Planning Commission

Wednesday, May 17, 2023

**TECHNICAL REVIEW PLAT REQUIREMENTS
REGULAR PLANNING COMMISSION MEETING
MAY 17, 2023**

2. [23-0823](#) 23PL1044
MCNORTON SUBDIVISION #2, BLOCK 4, LOTS 12A & 12B
(REPLAT-0.52 ACRES)
Located north of McNorton Rd. and west of Caroline Rd.

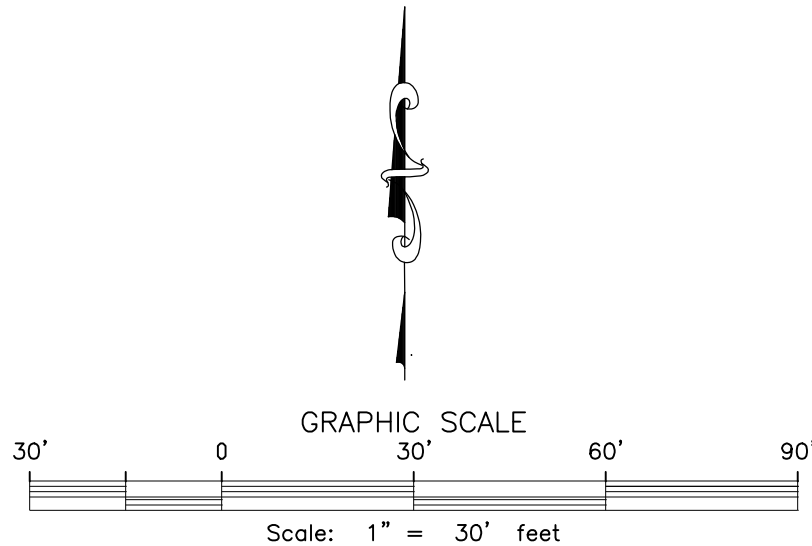
GIS						
No.	Sheet	Comment	Applicant Response	Staff Resolution	Applicant Response	Staff Resolution
1	Plat	Plat closes to acceptable engineering standards. (TSPS Manual of Practice Appendix A, Condition 3; Suburban Traverse Error of Closure)	NOTED	Addressed		
2	Plat	Northern adjacent lot volume and page information is incorrect. Refer to V69 Pg811 MRNCT.	DONE	Addressed		
3	Plat	All blocks are to be labeled on the plat area, preferably using a circled number.	DONE	Addressed		
LAND DEVELOPMENT						
No.	Sheet	Comment	Applicant Response	Staff Resolution	Applicant Response	Staff Resolution
1	Plat	Make plat boundary line thicker.	DONE	Addressed		
2	Plat	Label lots as Block 4 with circled number.	DONE	Addressed		
3	Plat	Change Page number on adjoining lots for McNorton SD No. 2 to 31.	DONE, THANKS	Addressed		
4	Plat	Spelling error on plat note 5. Spellcheck document.	DONE	Addressed		
5	Fees	Single Family Water Lot Fees: 1 x 220.22 = \$220.22	NOTED	Prior to Recordation

No.	Sheet	Comment	Applicant Response	Staff Resolution	Applicant Response	Staff Resolution
1	Plat	Water construction is not required for platting (UDC 1.2.1.D & 8.2.6; Water Distribution Standards).	NOTED	Addressed		
2	Plat	Wastewater construction is not required for platting (UDC 1.2.1.D & 8.2.7; Wastewater Collection System Standards).	NOTED	Addressed

No.	Sheet	Comment	Applicant Response	Staff Resolution	Applicant Response	Staff Resolution
1	Plat	This replat is not located along an existing or foreseeably planned CCRTA service route.	NOTED	Addressed

Plat of WHITECAP NORTH PADRE ISLAND Unit 1B

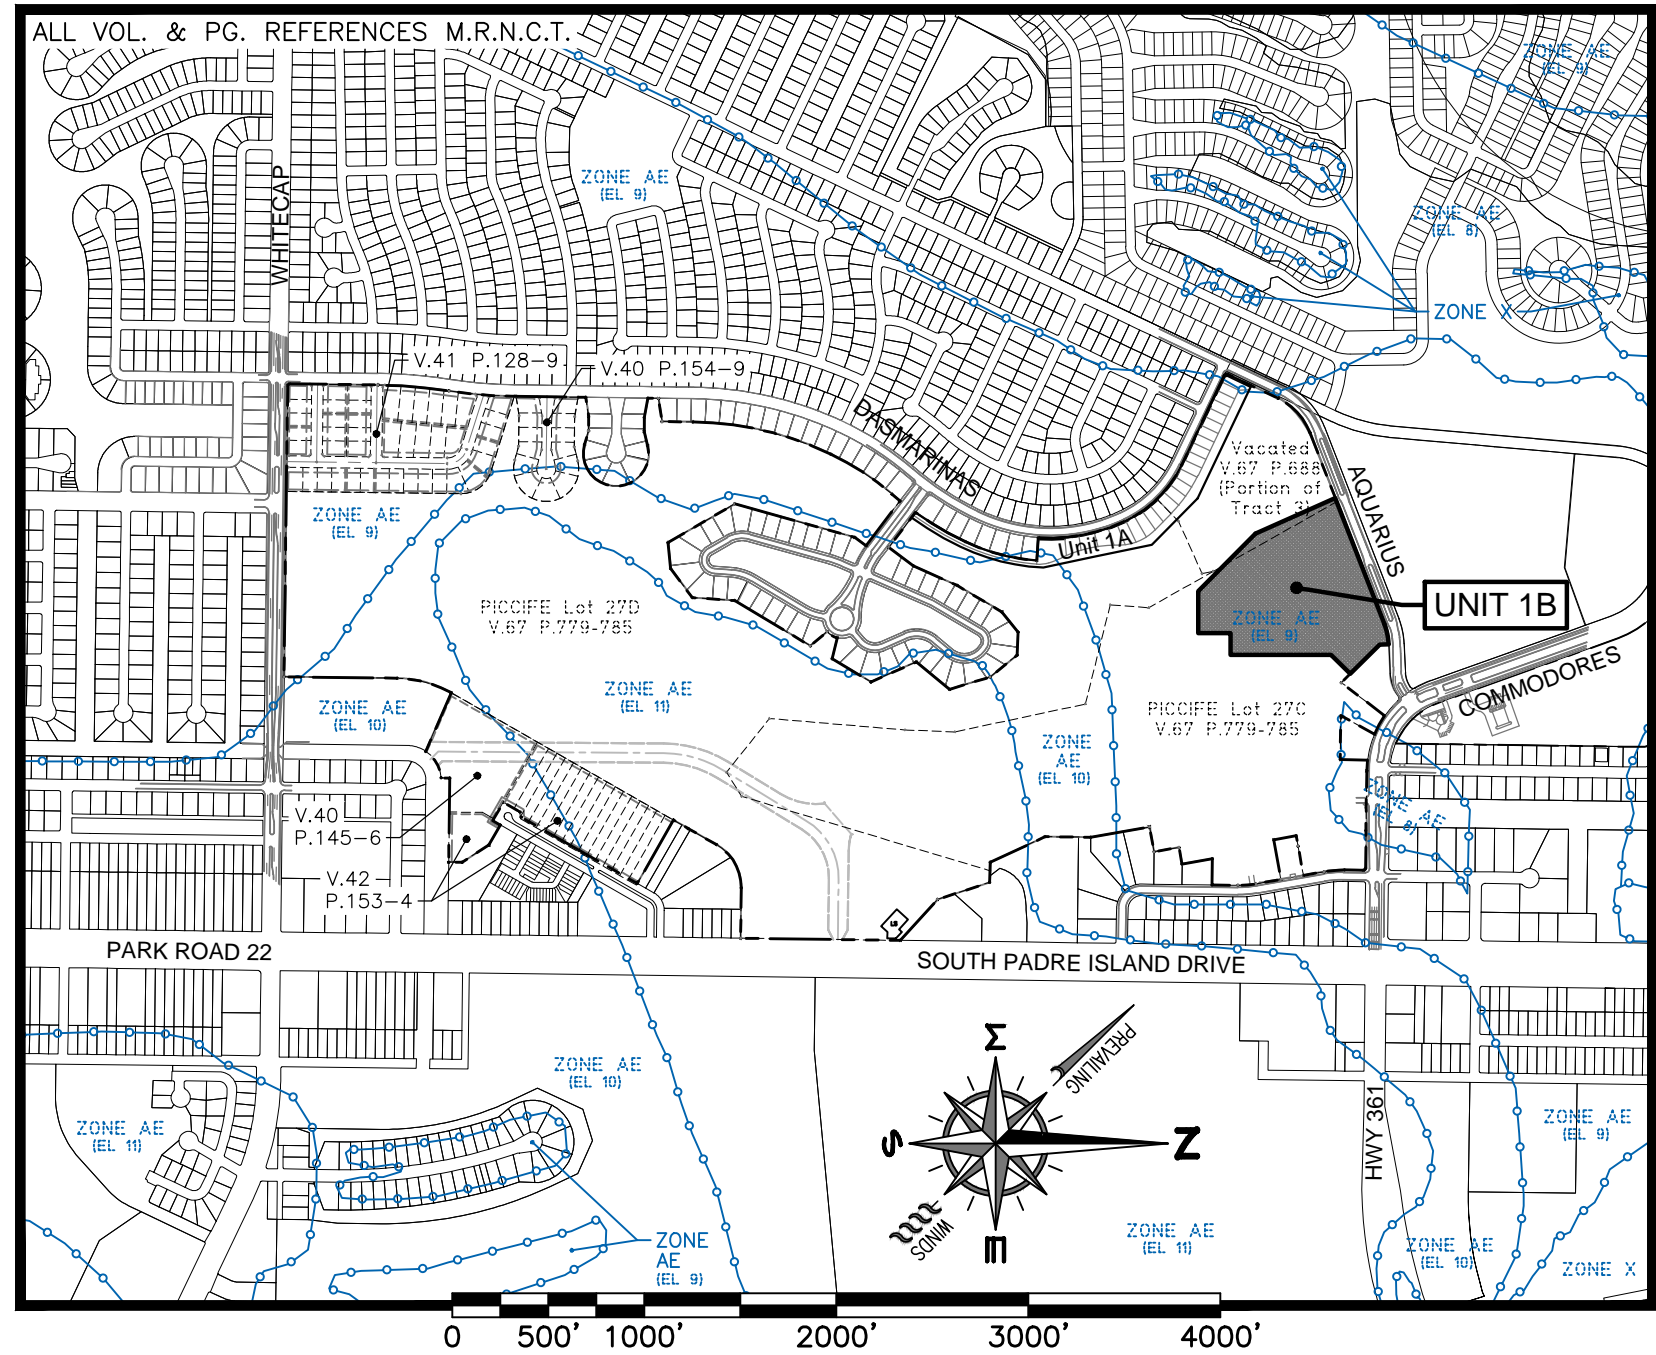
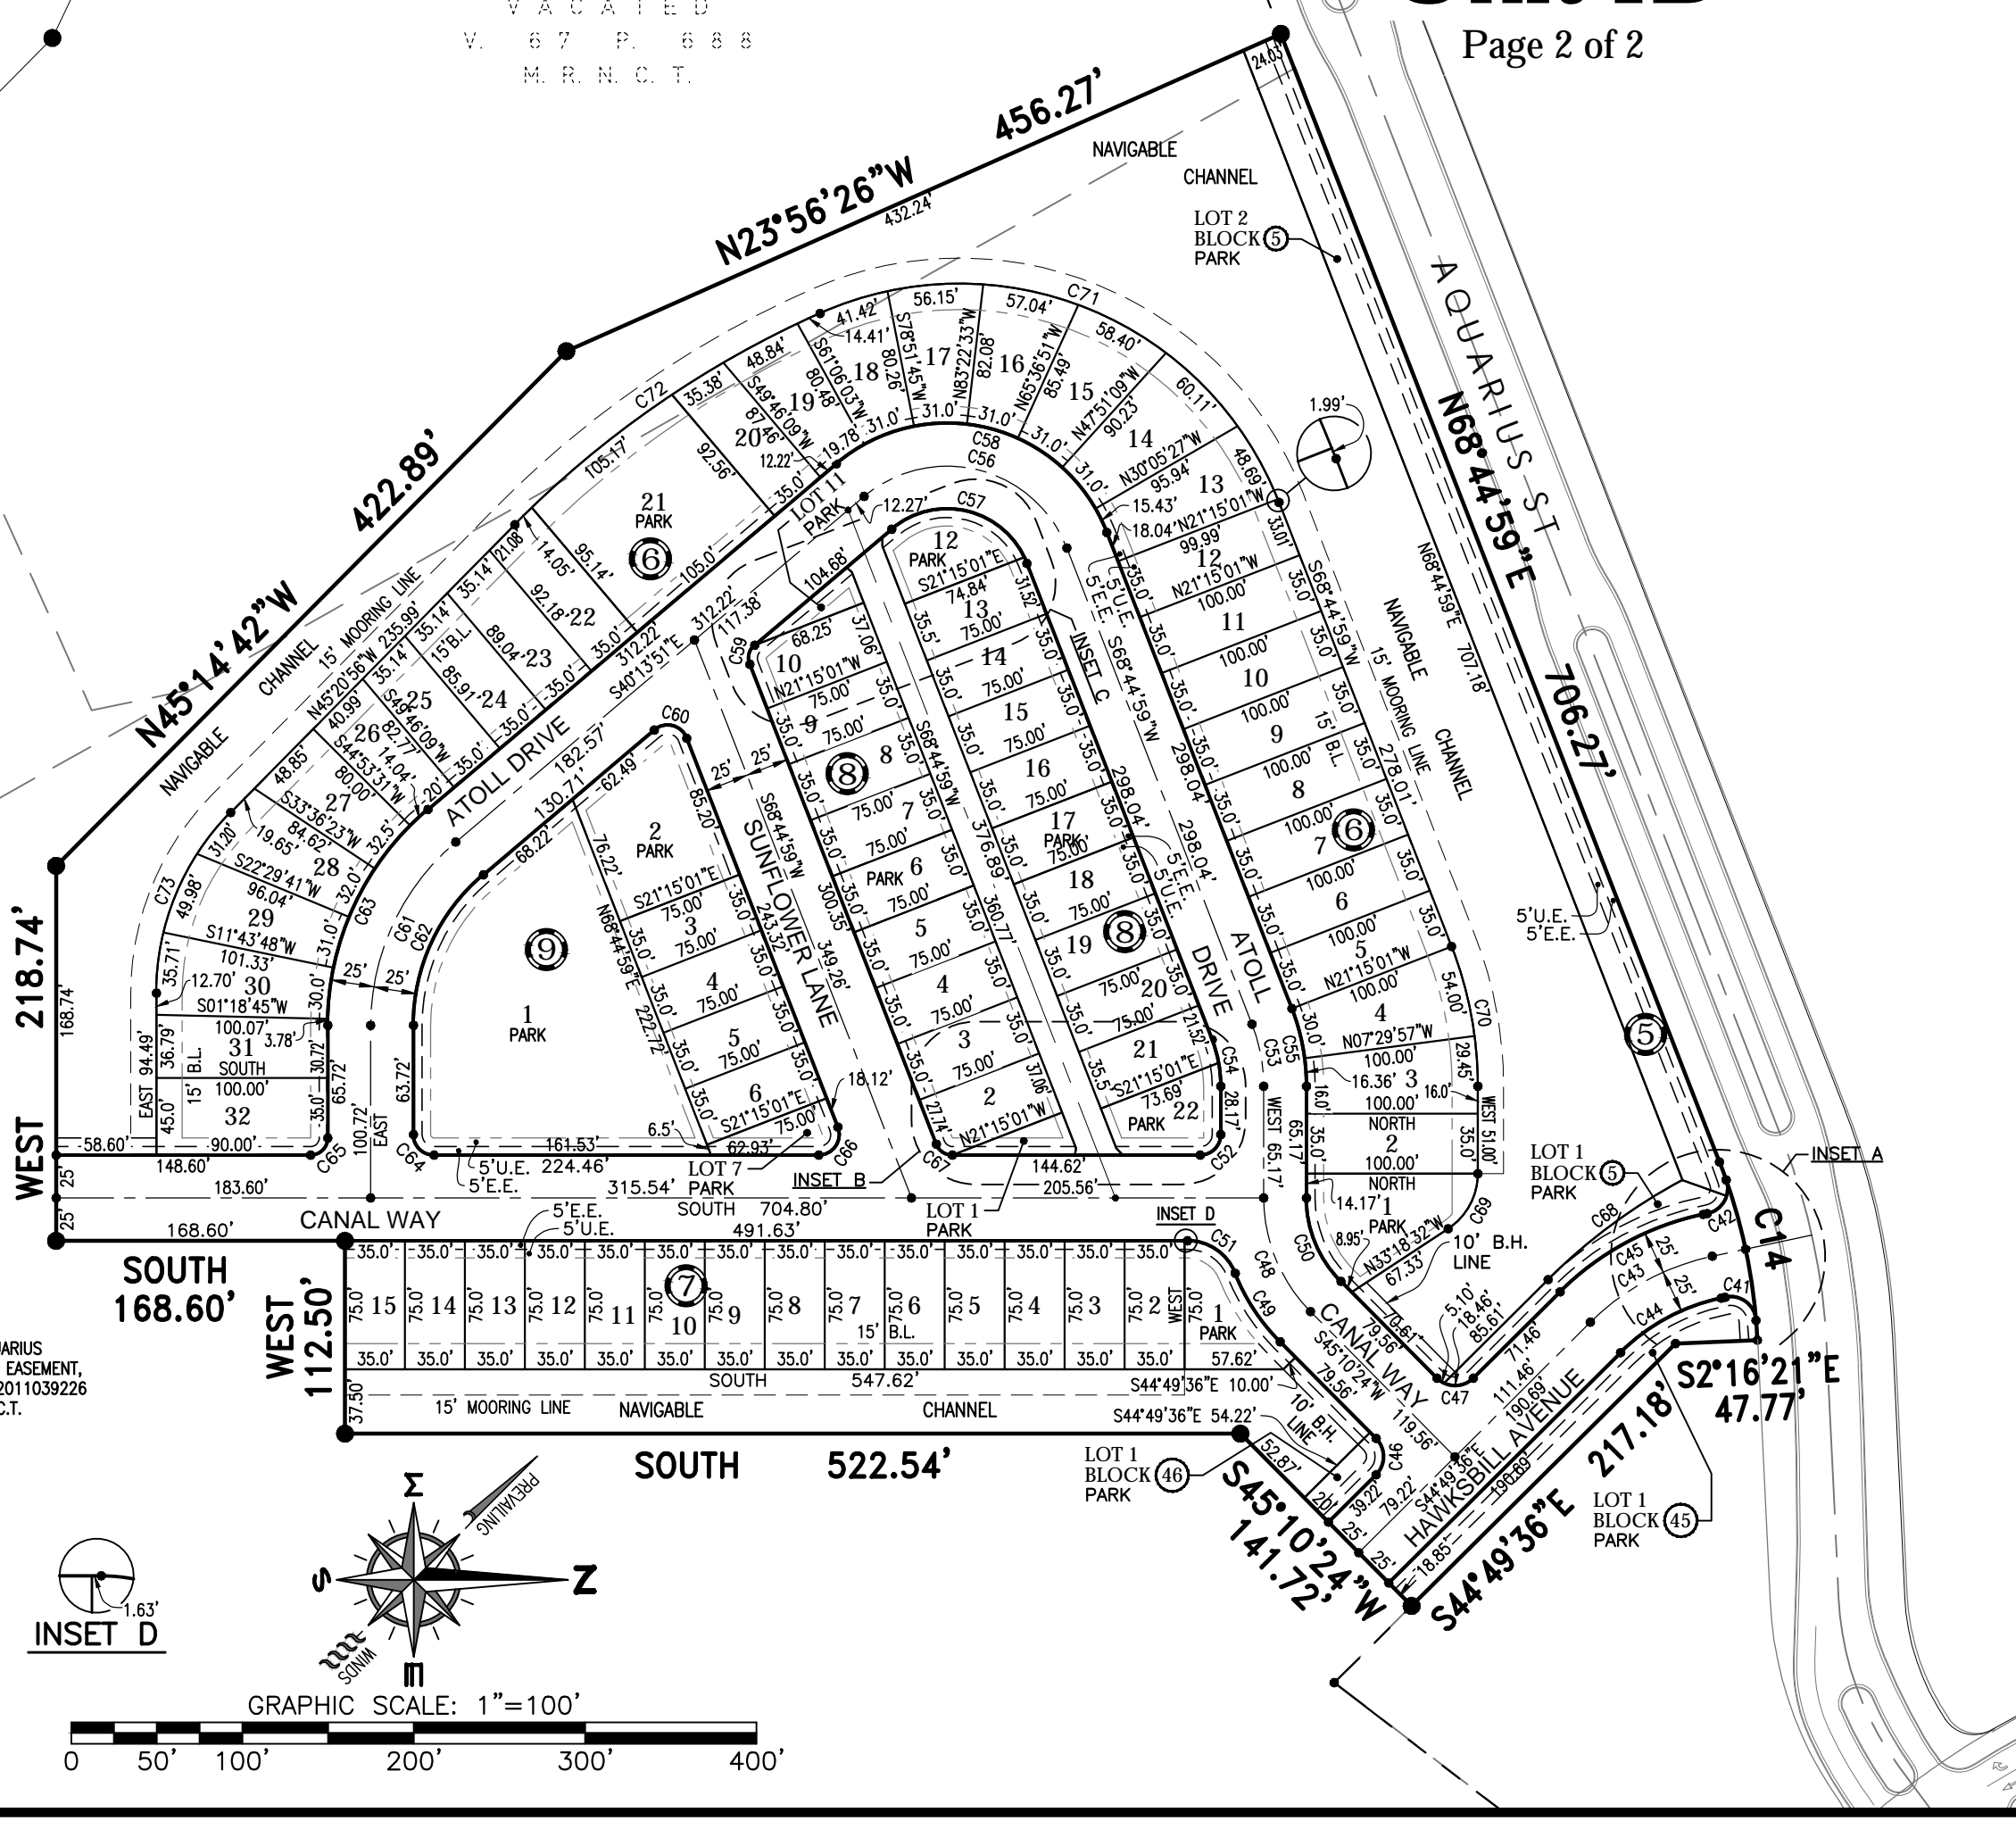
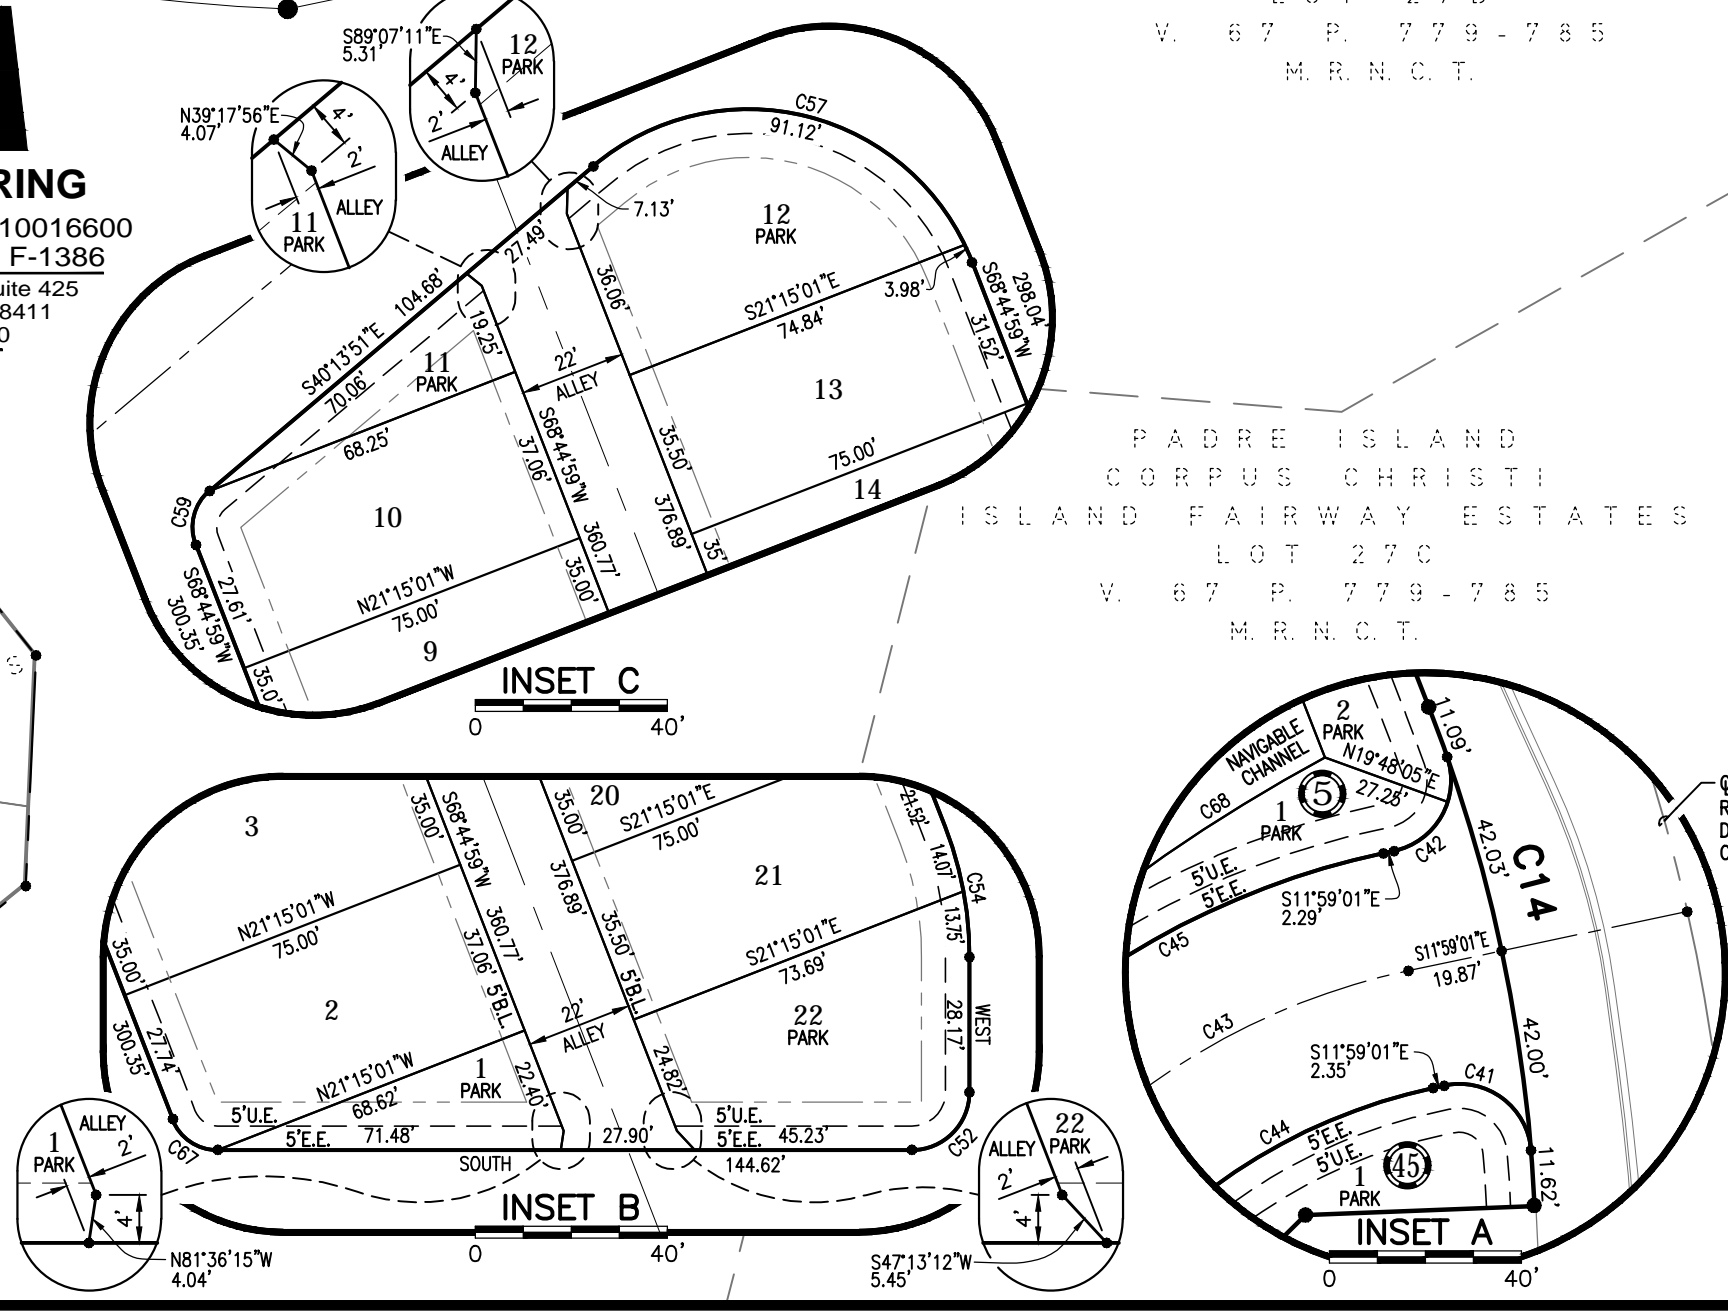
6	Plat 2	Provide Bold type labels for each phase Unit within each Unit boundary for each sheet.	Complete.	Addressed		
6	Plat 2	Provide Flood plain boundaries with labels on plat or verify Plat note 2 indicating entire property is in AE zone. Provide contours in light weight lines on plat.	Complete, noting that the addition of contours necessitated the addition of the existing bulkheads. Additionally, note that the plat displays the contours following the Site Work improvements that are currently nearing completion, while the SWQMP displays the pre-existing contours.	Not addressed. New construction contours to be on Public Improvement plans (Remove from plat). Existing contours requested are by the Prelim plat application checklist. Remove floodplain boundaries from Sheet 1 Phasing Plan. See previous submitted Sheet 1. Do not change as submitted.		
6	Plat 2	Provide legal description, ownership and recording information for adjacent south and north adajacent properties.	Complete.	Addressed

7	Plat 2	Provide "Private Park" label for Block 5, Lot 2 & 3. Provide "Private" to all Park lots on all sheets.	"Park" label added. General Notes on Sheet 1 designate all parks as private.	Not Addressed. Label as "Private Park" on plat.		
8	Plat 2	Provide lot and block number for Navigable Channel. Area to be included in Final plat and recorded as a Lot. Square footage should be provided. Include Navigable channel to note 8 and additional requested on LD comment #5.	This plat is notated and numbered in accordance with the precedent set by the existing island subdivisions (e.g., see Coquina Bay, Barataria Bay, Point Tesoro, Ports O' Call, etc.). Square footages of Navigable Channels have been added within the plan. Note that assigning lot numbers would 'tie' blocks together across the channels, for example, converting the channel between Units 1A and 1E to a lot would combine Blocks 1, 2, 12, & 14 into a single block. And to the extreme, numbering the channel east of Phase 1B would combine Blocks 7, 11, 15, 16, 17, & 46 into a single block spanning Phases 1B, 1C, 1D, and 1E.	Addressed; further maintenance obligation to be on Developer Agreement.

10	Plat 2	Proposed bio swales to be in Private Drainage Easements labeled on the plat.	Complete. See Land Development Comment 3 above.	No Addressed. Label as "Private DE" on plat.		
11	Plat 2	Lift stations and WW lines to be in easements, whether in Private UE or public UE.	Utility Easements have been added to all lines and will Lift Station easements will be added during the Final Platting/Construction Drawings phase of work to fully encompass the limits of the Lift Station infrastructure.	To be Addressed with Final Plat		
12	Plat 2	Utility lines outside plat boundary to be in an Easement recorded separately and labeled with document number on Final plat. Show easement for force main outside boundary.	Acknowledged, including addition of Offsite Utility Easements for Wastewater, as applicable.	To be Addressed with Final Plat		
13	Plat 3	Provide legal description, ownership and recording information for all adjacent properties on Commodores Dr. and Compass St.	Complete.	For adjacent properties with a recorded plat, only the Subdivision name and volume/page of Plat is required (one label). For properties not platted, the owners name and document number is required for each property. All easements, lot labels, and setback labels should be shown.

14	Plat 3	Indicate what are the dashed lines parallel with Compass Street. Provide label if need to.	Complete. Labels added.	To be Addressed with Final Plat		
15	Plat 3	Provide and label the centerline for Park Road 22.	Complete.	Addressed		
16	Plat 3	Provide half street distance to platted property for Aquarius St., Commodores Dr. and Compass St.	Complete.	Addressed		
17	Plat 5	Indicate what are the dashed lines parallel with east boundary is for. Provide label if need to.	Complete. Labels added.	To be Addressed with Final Plat		
18	Plat 5	Provide and label the centerline for Park Road 22.	Complete.	Addressed		
19	Plat 5	Provide legal description, ownership and recording information for all adjacent west and east properties	Complete.	For adjacent properties with a recorded plat, only the Subdivision name and volume/page of Plat is required (one label). For properties not platted, the owners name and document number is required for each property. All easements, lot labels, and setback labels should be shown.

20	Plat 6	Indicate and label the property whether it is a Private Park or Navigational waters. Provide a Block and Lot number.	Complete.	Addressed		
21	Plat 6	Verify the platted lots (dashed) will be listed on the Final plat description with verification of ownership with application.	Acknowledged.	Addressed

22	Plat 7	Provide legal description, ownership and recording information for all adjacent west and east properties	Complete.	For adjacent properties with a recorded plat, only the Subdivision name and volume/page of Plat is required (one label). For properties not platted, the owners name and document number is required for each property. All easements, lot labels, and setback labels should be shown.		
23	Plat 7	Verify the platted lots (dashed) will be listed on the Final plat description with verification of ownership with application.	Acknowledged.	Addressed		
24	Plat 7	Indicate and label the property whether it is a Private Park or Navigational waters. Provide a Block and Lot number.	Complete.	Addressed		
25	Plat 8	Verify the platted lots (dashed) will be listed on the Final plat description with verification of ownership with application.	Acknowledged.	Addressed		
26	Plat 8	Indicate and label the property whether it is a Private Park or Navigational waters. Provide a Block and Lot number.	Complete.	Addressed

27	Plat 8	Provide half street distance to platted property for Dasmarias Dr. and Whitecap Boulevard.	Complete.	Not Addressed.		
28	Plat 8	Provide legal description, ownership and recording information for all adjacent east properties	Acknowledged.	For adjacent properties with a recorded plat, only the Subdivision name and volume/page of Plat is required (one label). For properties not platted, the owners name and document number is required for each property. All easements, lot labels, and setback labels should be shown.		
29	Plat 9	Indicate and label the property whether it is a Private Park or Navigational waters. Provide a Block and Lot number.	Complete.	Addressed		
30	Plat 9	Verify the platted lots (dashed) will be listed on the Final plat description with verification of ownership with application.	Acknowledged.	Addressed		
31	Plat 9	Provide and label the centerline for Park Road 22 and Cruiser Street.	Acknowledged.	Addressed

32	Plat 9	Provide legal description, ownership and recording information for all adjacent east properties	Acknowledged.	For adjacent properties with a recorded plat, only the Subdivision name and volume/page of Plat is required (one label). For properties not platted, the owners name and document number is required for each property. All easements, lot labels, and setback labels should be shown.		
33	Utility Plan	On Utility plan, indicate what utilities are existing and which are proposed by providing these labels.	Existing and Proposed Utilities are defined graphically and noted in the legend. Additionally, existing utility notations have been added.	To be Addressed with Final Plat

34	Plat (all sheets)	Remove or correct the bold dotted lines as Bearings and distances for the boundary. Boundary is not checked by GIS for closure.			
----	-------------------	---	--	--	--
